PROPOSAL REQUEST

PROJECT: Holiday Park - Remodeling
(Name and address) 5401 Holiday Park Boulevard
North Port, Florida 34287

ARCHITECT'S PROJECT NO.: HL 21-1163

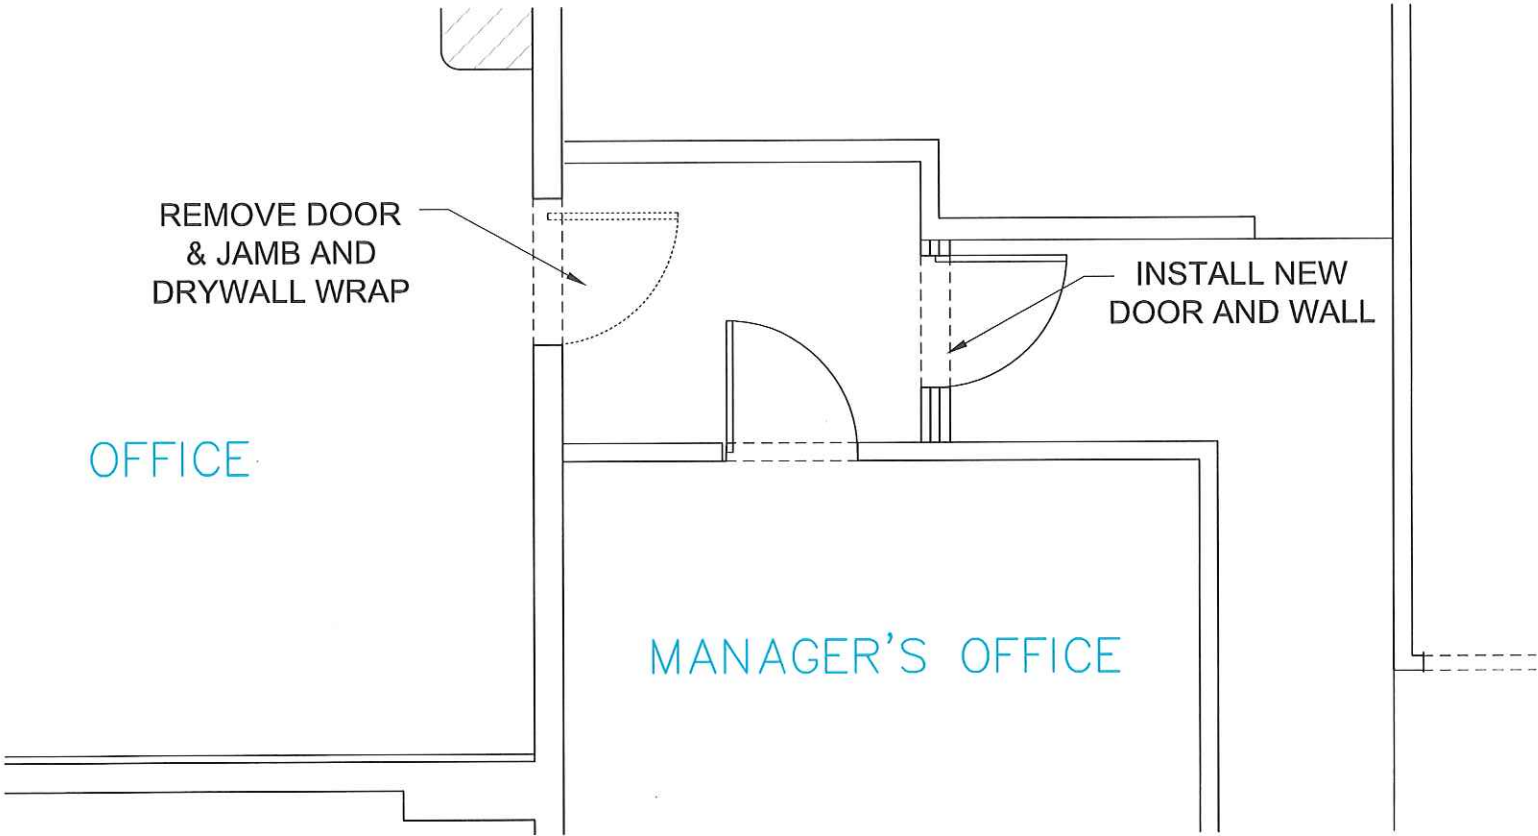
Remove existing door from Office to Manager's Hall, and drywall wrap. Install new door and Wall area further down the Hall.

REMOVE DOOR
& JAMB AND
DRYWALL WRAP

INSTALL NEW
DOOR AND WALL

NEW DOOR INSTALL IS REMOVED.
COST TO REMOVE + DRYWALL OPENING IS
UNDER \$1000.00

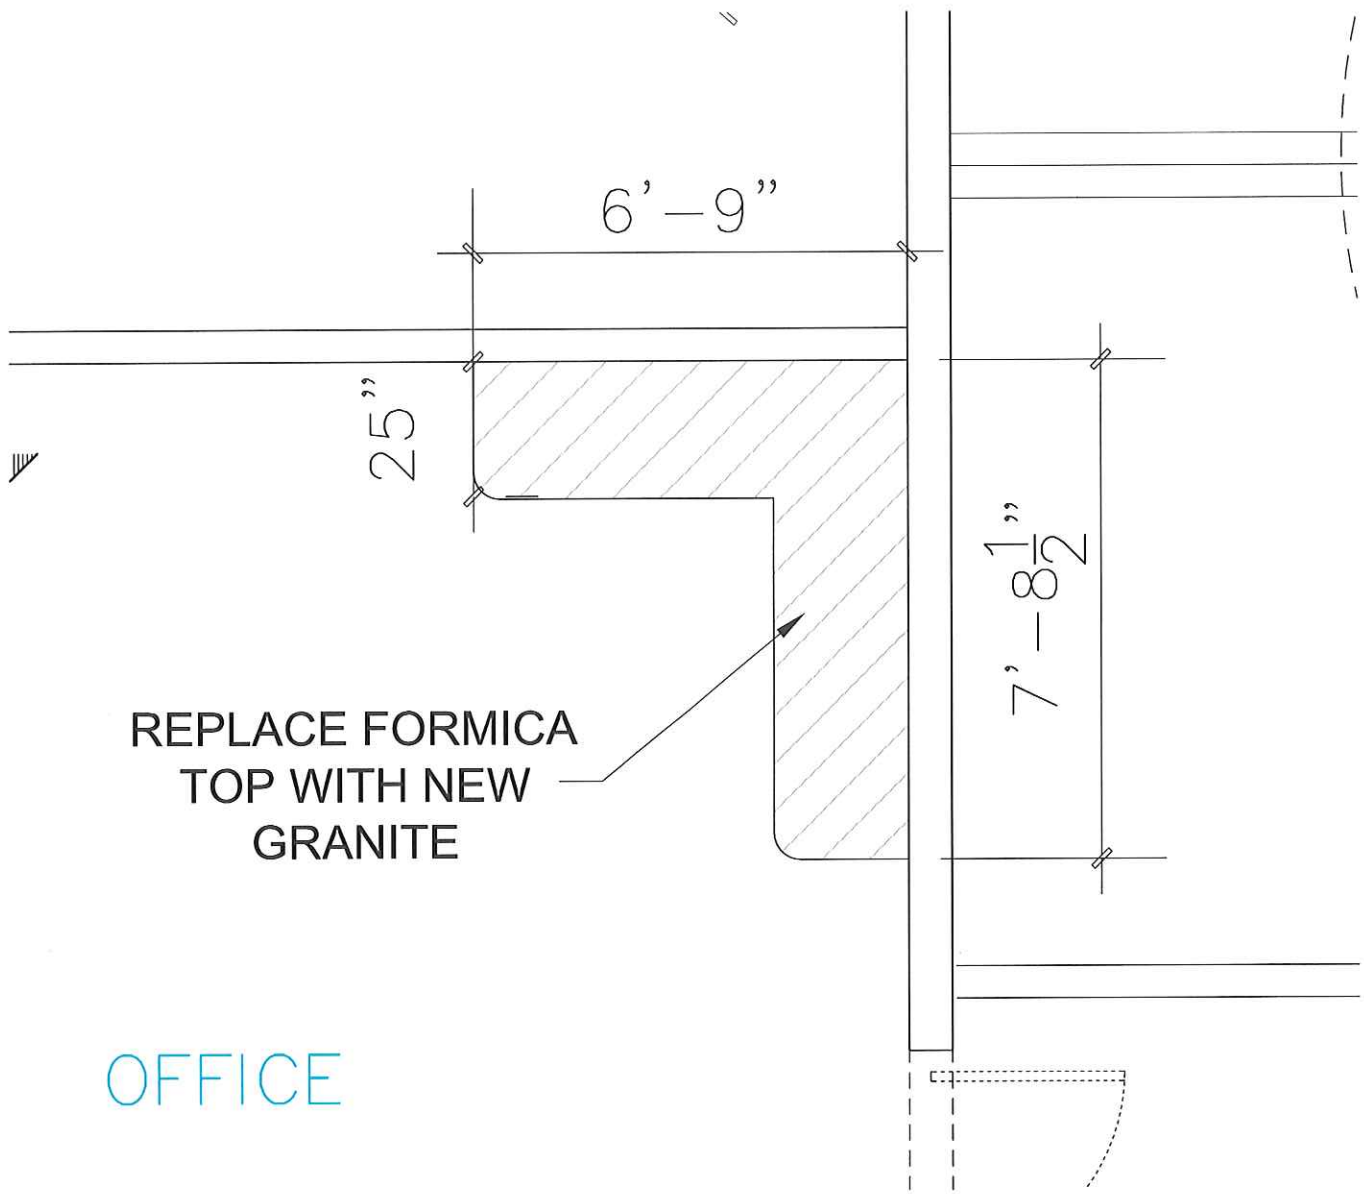
Replace existing formica countertop to granite on existing cabinet, to match original project scope.

REMOVING GRANITE, PUTTING FORMICA
COST \$2500.00

NEW BEAM REPLACEMENT

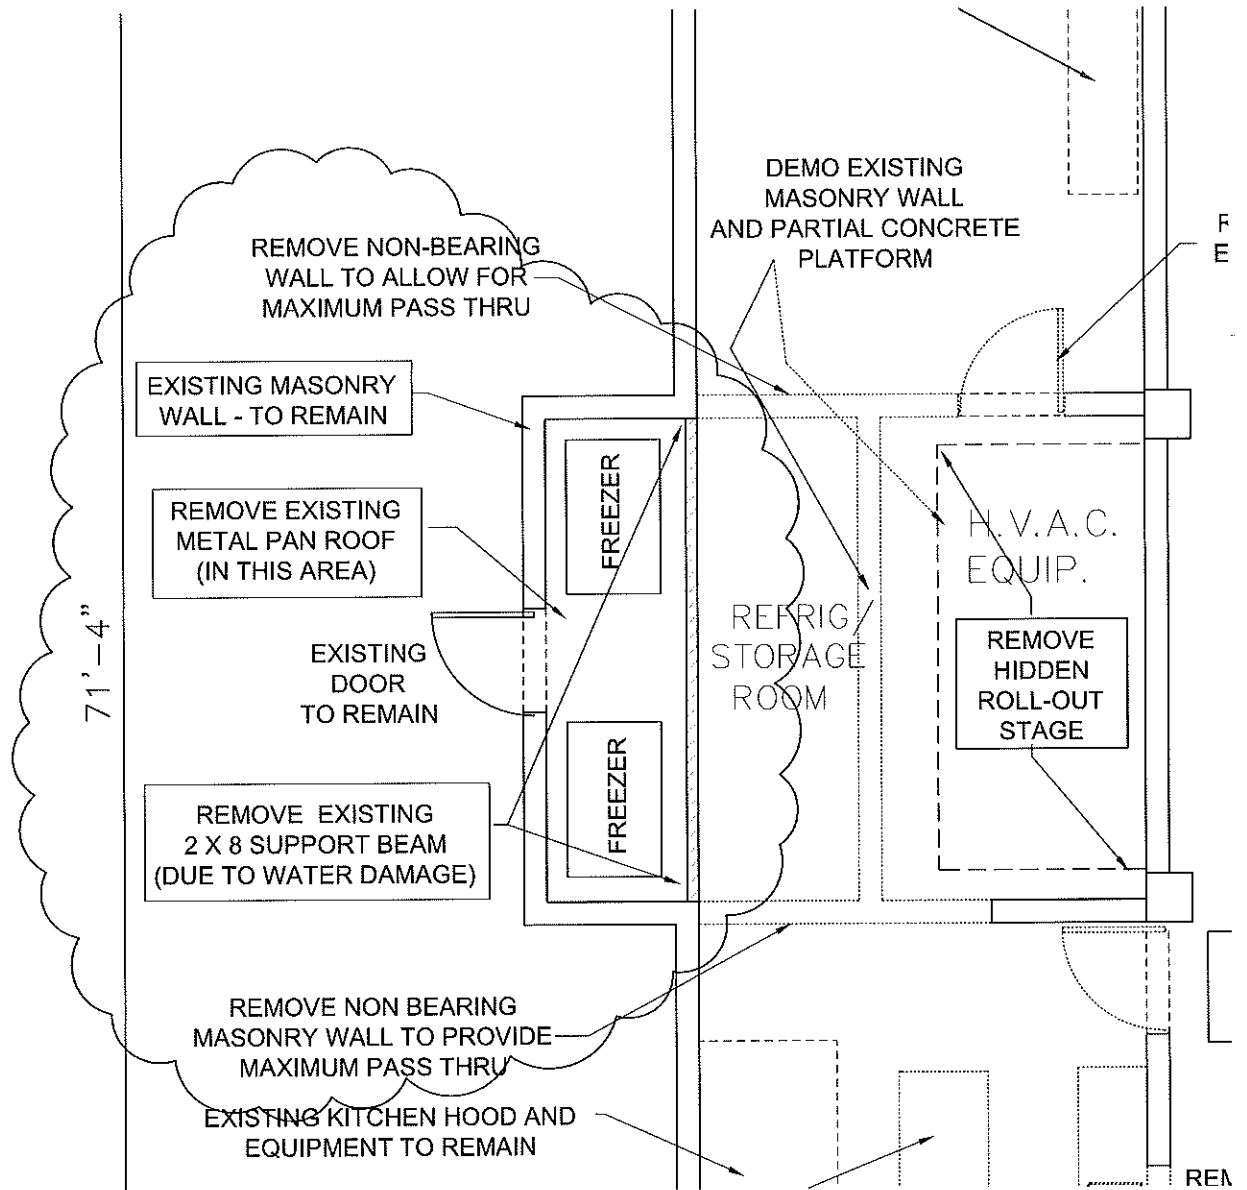
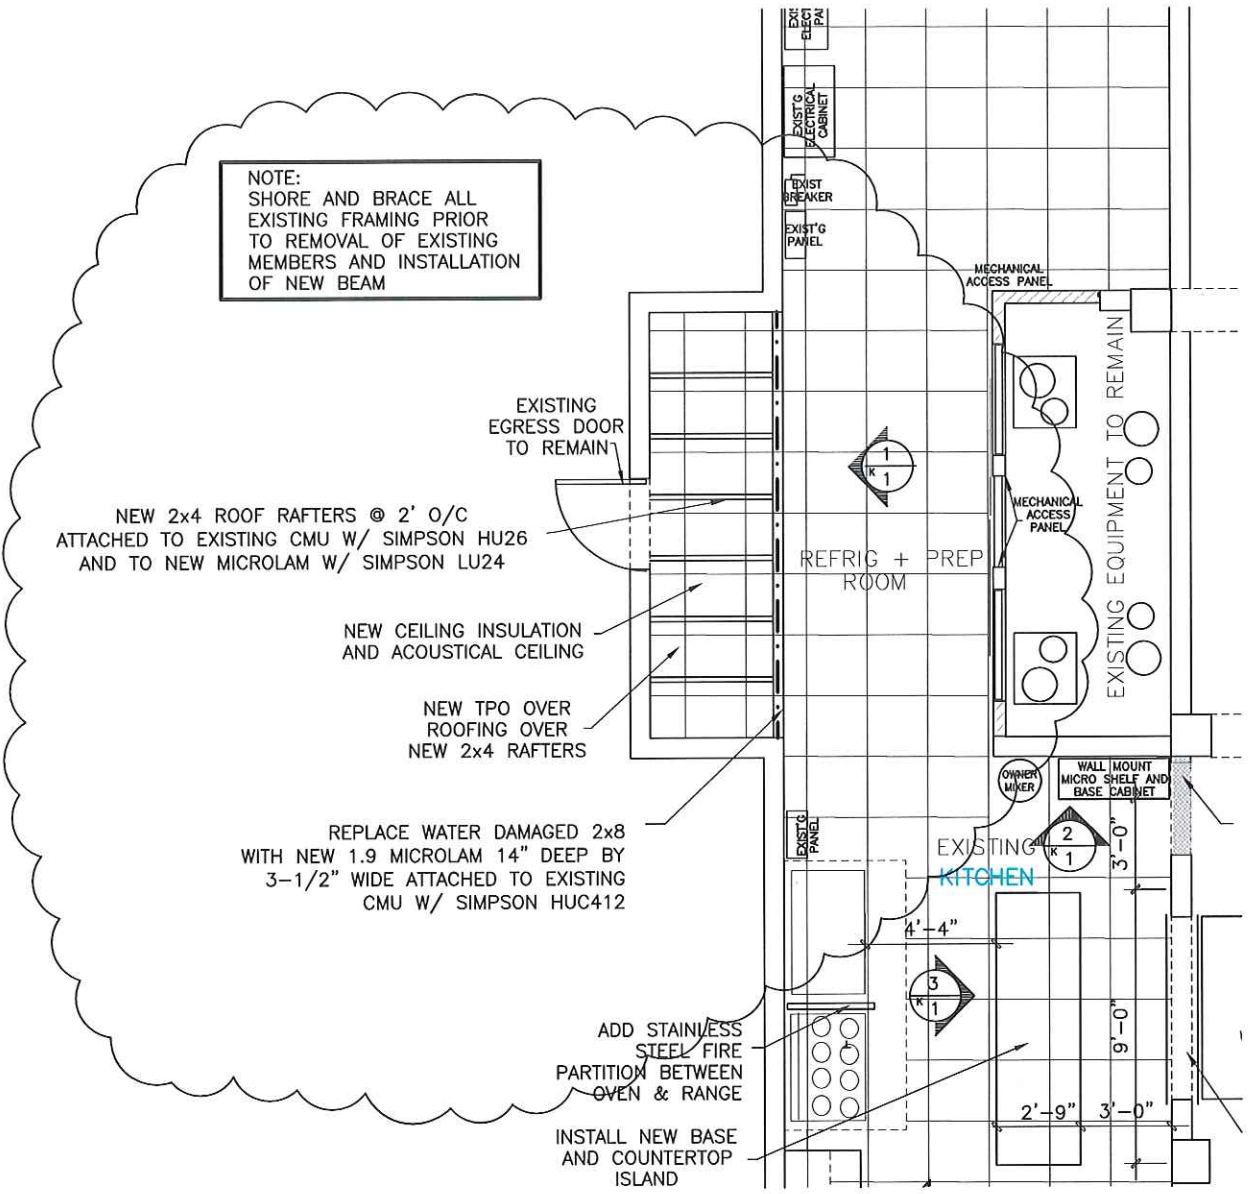
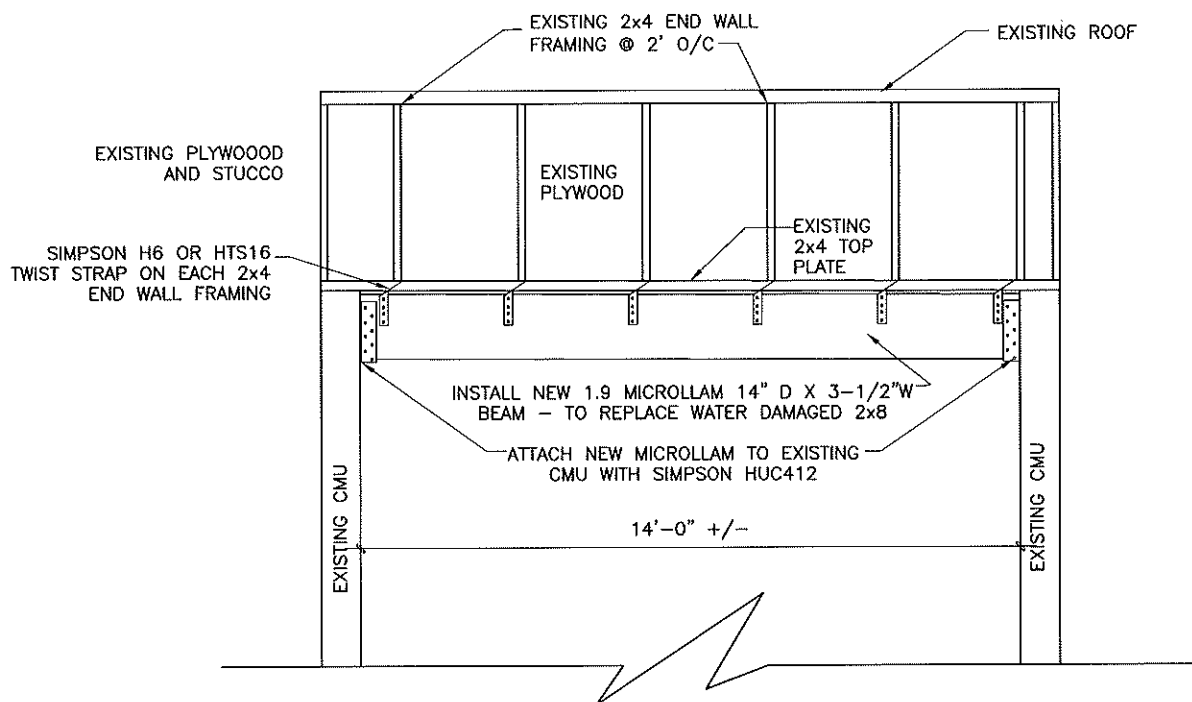
Replace existing water damaged structural wood member and replace with Engineered Lumber. Remove existing non-compliant metal roof over Refrigerator Room and replace it with new 2x4 roof joists, insulation, and TPO roof.

NOTE:
SHORE AND BRACE ALL
EXISTING FRAMING PRIOR
TO REMOVAL OF EXISTING
MEMBERS AND INSTALLATION
OF NEW BEAM

NEW 2x4 ROOF RAFTERS @ 2' O/C
ATTACHED TO EXISTING CMU W/ SIMPSON HU26
AND TO NEW MICROLAM W/ SIMPSON LU24

NEW CEILING INSULATION
AND ACOUSTICAL CEILING

NEW TPO OVER
ROOFING OVER
NEW 2x4 RAFTERS

REPLACE WATER DAMAGED 2x8
WITH NEW 1.9 MICROLAM 14" DEEP BY
3-1/2" WIDE ATTACHED TO EXISTING
CMU W/ SIMPSON HUC412

ADD STAINLESS
STEEL FIRE
PARTITION BETWEEN
OVEN & RANGE

INSTALL NEW BASE
AND COUNTERTOP
ISLAND
